ADJUSTMENT FOR ALL THE 2B-QIBARLEDI3 BARRIER.

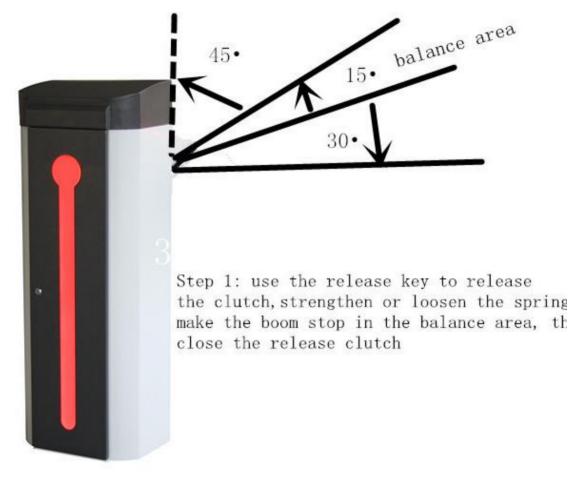
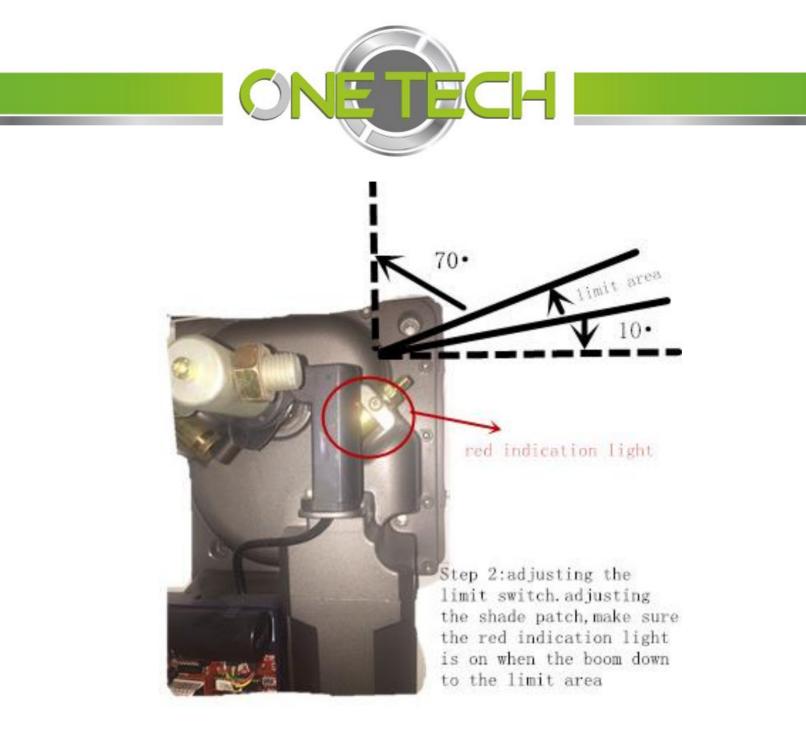
The attached picture is to make the adjustment for all the 2B-QIBARLEDI3 barrier.

Currently for the 2B-QIBARLEDI3 barrier, if the boom is 4m, then need to change a bigger spring, the 7.0mm spring.

When is not posible to change we need to streng the spring to the MAX postion.

Make sure all your tehcnial person keep it in mind, the best way is every three months check the balance and adjust it. This mantain is very easy, I think 3min/pc the most.
